MONUMENT RIDGE EAST FILING NO. 1 CONSTRUCTION DRAWINGS

EL PASO COUNTY, COLORADO

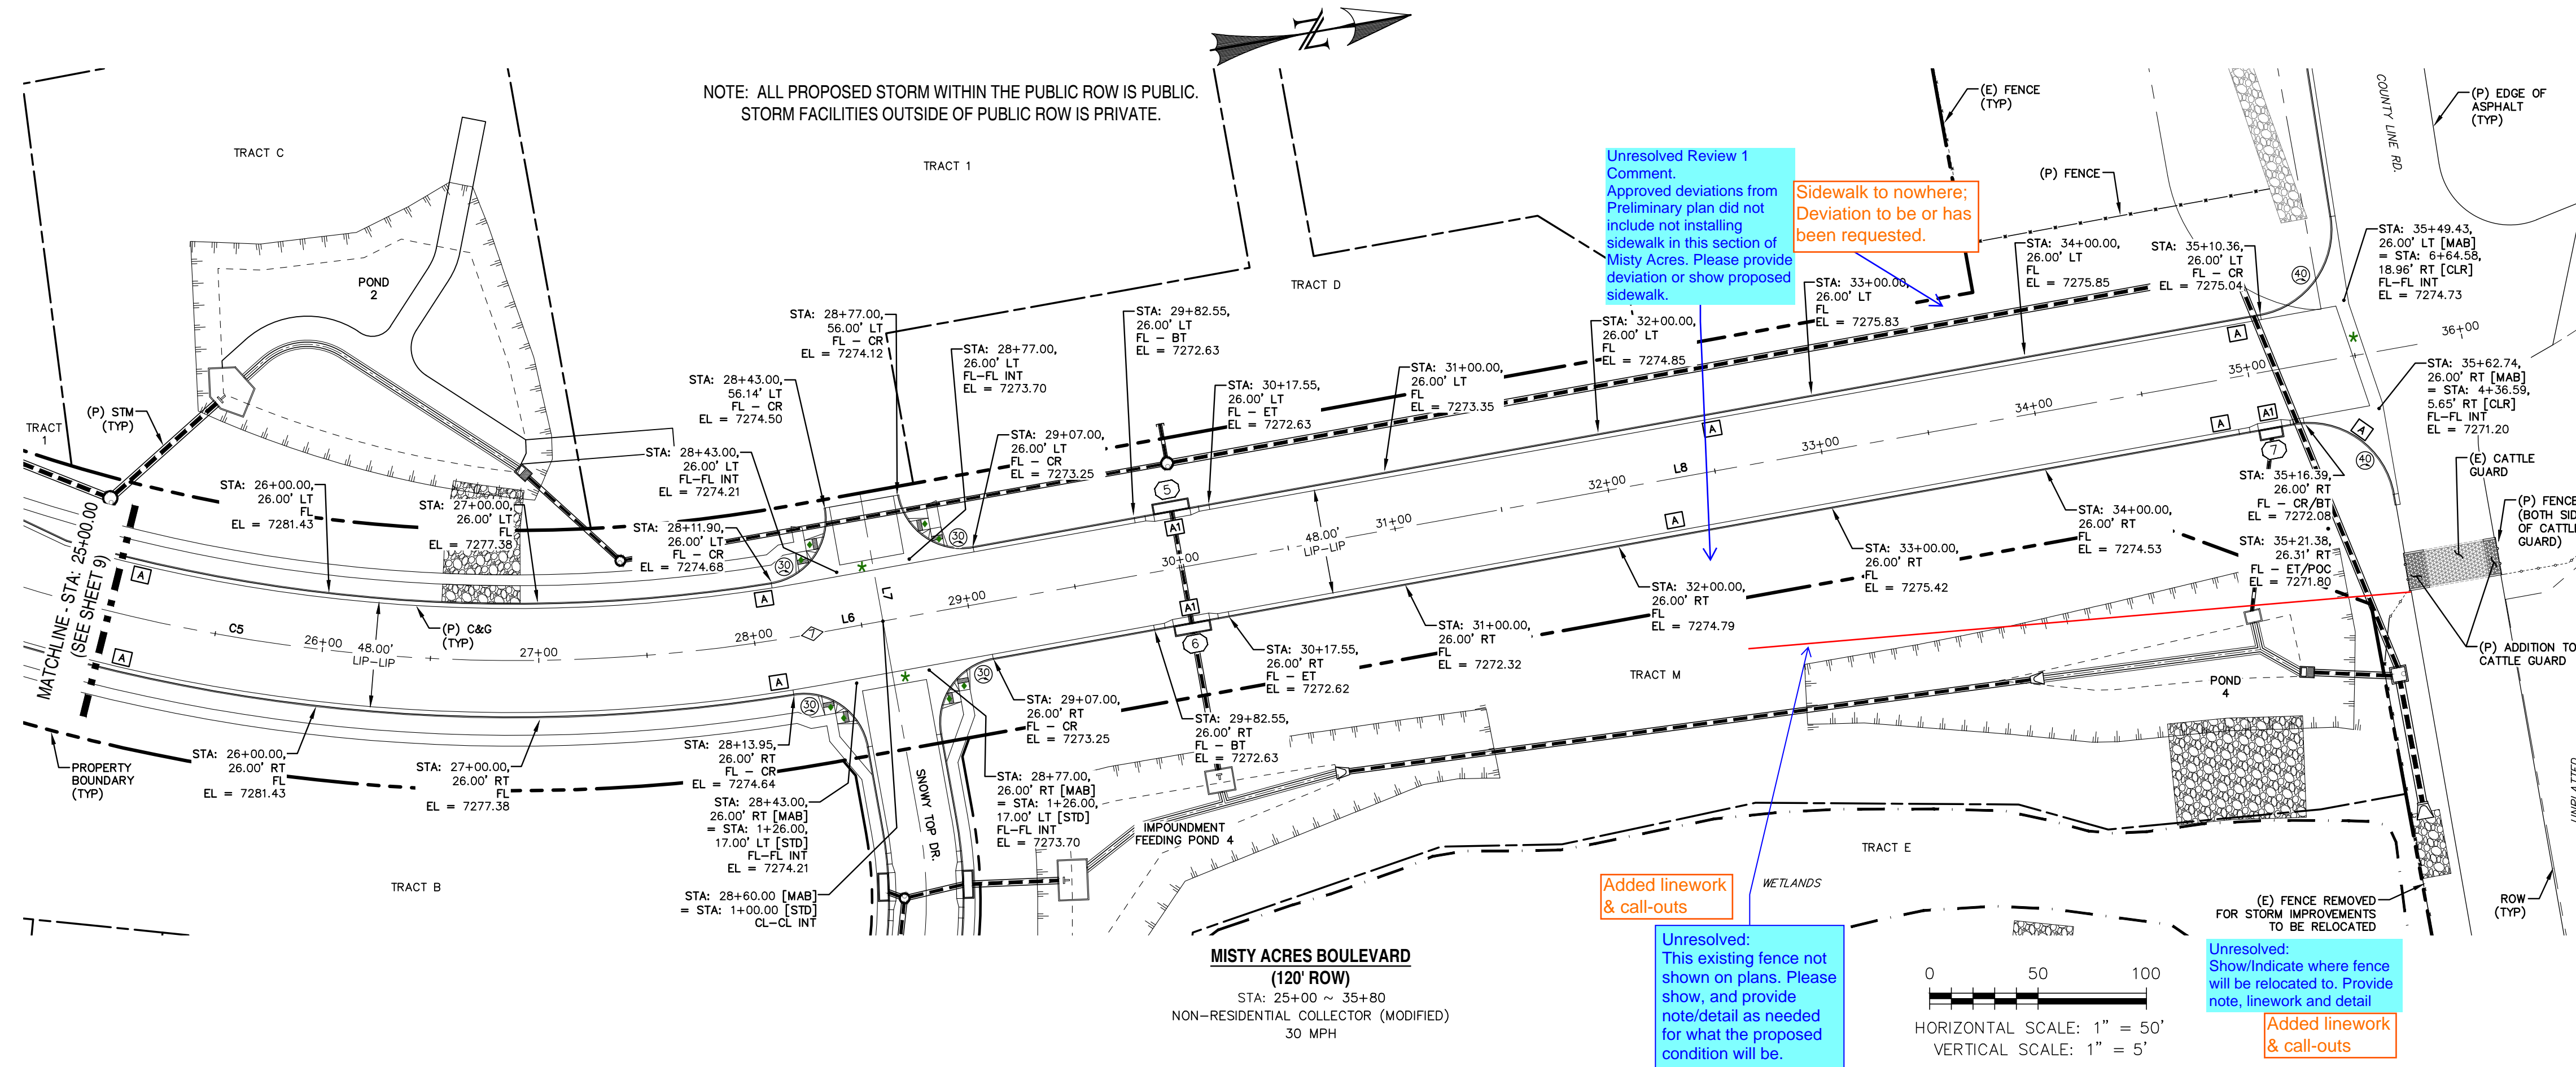
Unresolved Review 1 Comment:
Approved deviations from Preliminary plan did not include not installing sidewalk in this section of Misty Acres. Please provide deviation or show proposed sidewalk.
